Planning Commission Amendments to UNO Revision, August 2019

*Explanation and back-up material for PC
amendments and one potential amendment*

September 17, 2019

PC Amendments to UNO Ordinance

BUILDING HEIGHT FACTORS

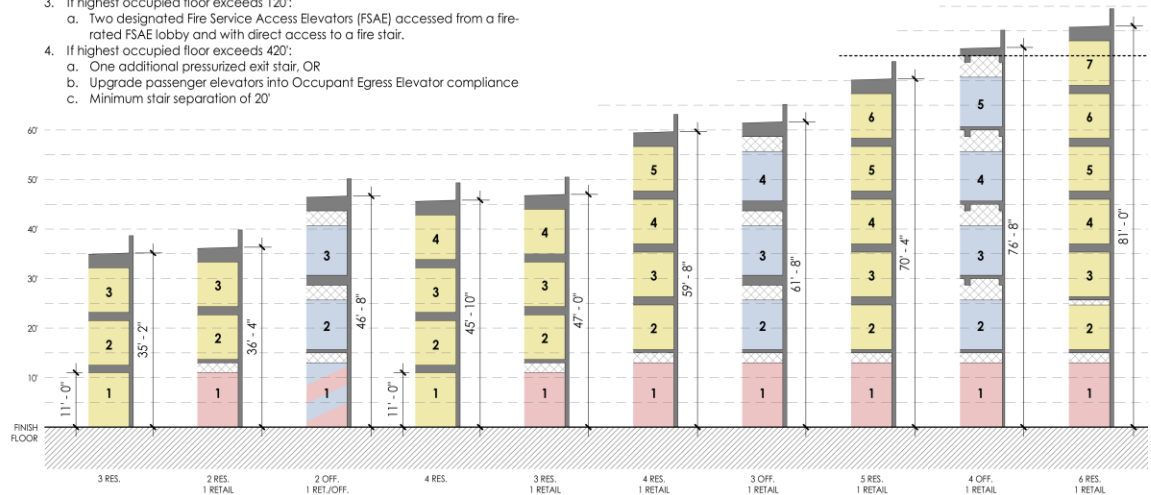
- Proposed height allows good bonus performance:**

- A 20' bonus allows 40' and 45' properties to reach 60'/65', a good natural height for 4 stories of residential over an activated ground floor.
- Allows an additional ~2 stories making bonus attractive and encouraging redevelopment and affordable unit production.
- Source: Planning Commission Non-Residential Zone Working Group Study of Building Heights

Amdt 5: Expansion of Inner West Campus District (7-5)

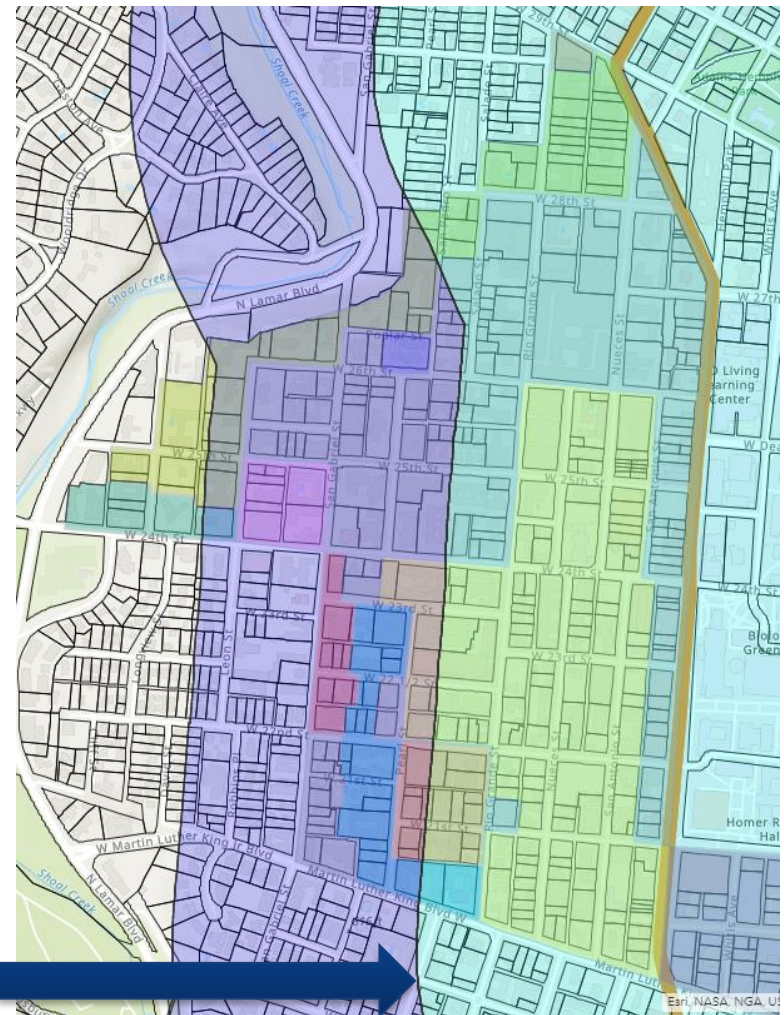
Expansion brings sub-district across Rio Grande, unlocking several properties for affordable bonus redevelopment. *(Not in draft ordinance.)*

- **Expansion was requested by property owner**
 - Owner of lot at 2404 Rio Grande (boxed property second-from-bottom below) requested extension of Inner West Campus subdistrict across Rio Grande to his property.
 - Would increase base height (under proposed UNO amendment) of area from 75-90 ft. to 175 ft., and bonus height from additional 25 ft. to 125 ft.
- **Area has great potential for additional affordable housing.**
 - Area has had only one site redevelop under UNO.
 - Four boxed sites are attractive for redevelopment.
 - Large Inner West Campus bonus bonus would yield potentially dozens of affordable units.
- **No compelling reason not to.**
 - Presence of nearby fraternity houses cited as reason not to build more units under affordable bonus.
